Expedited System Impact Assessment Report

Final Report- Addendum Assessment Summary

Bruce Power Inc.

Bruce B Standby Generator Control Upgrades

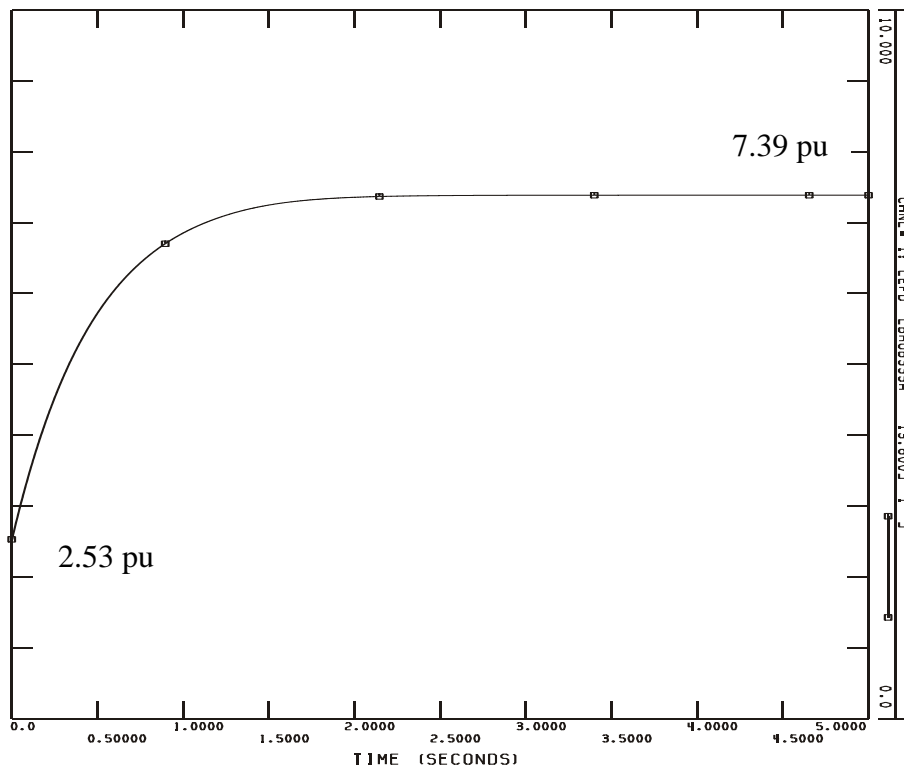
In the governor test, the change in the rotor speed is observed for a load step change of a certain magnitude. The IESO requires governors to have a permanent speed droop that can be set in the range between 3% and 7%. The response obtained for a 1% load increase from an initial machine loading of 50% of the generator's MVA rating is shown below along with a summary of the change in speed,

Δ Speed	-0.474487×10^{-3}
ΔP_{mec}	8.98×10^{-3}
Droop	5.3%

The droop is 5.4%, and thus meets the IESO criteria.

FRI, JUL 10 2009 13:56
RESPONSE RATIO

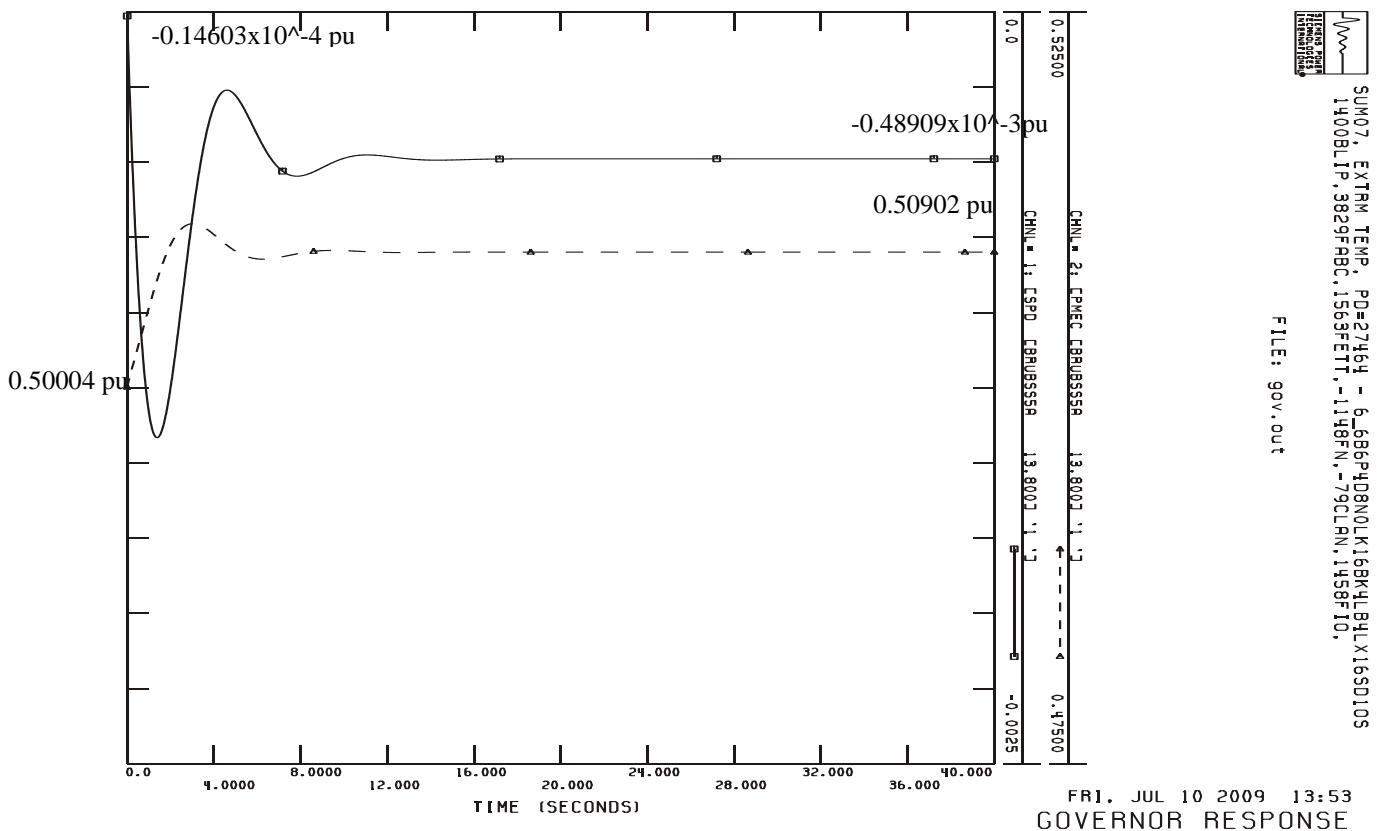
Studies with the Bruce B SG7 post-commissioning test model values indicate that the nominal response is 3.0 . As shown in the figure below, the positive ceiling voltage is 292% of the rated field voltage. These values are slightly lower than the nominal response and positive ceiling values obtained in the original SIA, however, the IESO lesser requirements are still satisfied.

A comparison of the post-commissioning nominal response (3.0) to that of the old exciter (1.0) indicates that the new AVR will result in better performance than the old AVR.

Therefore, this assessment concludes that the new AVR at Bruce SG units will have a performance that meets or exceeds the old AVR.
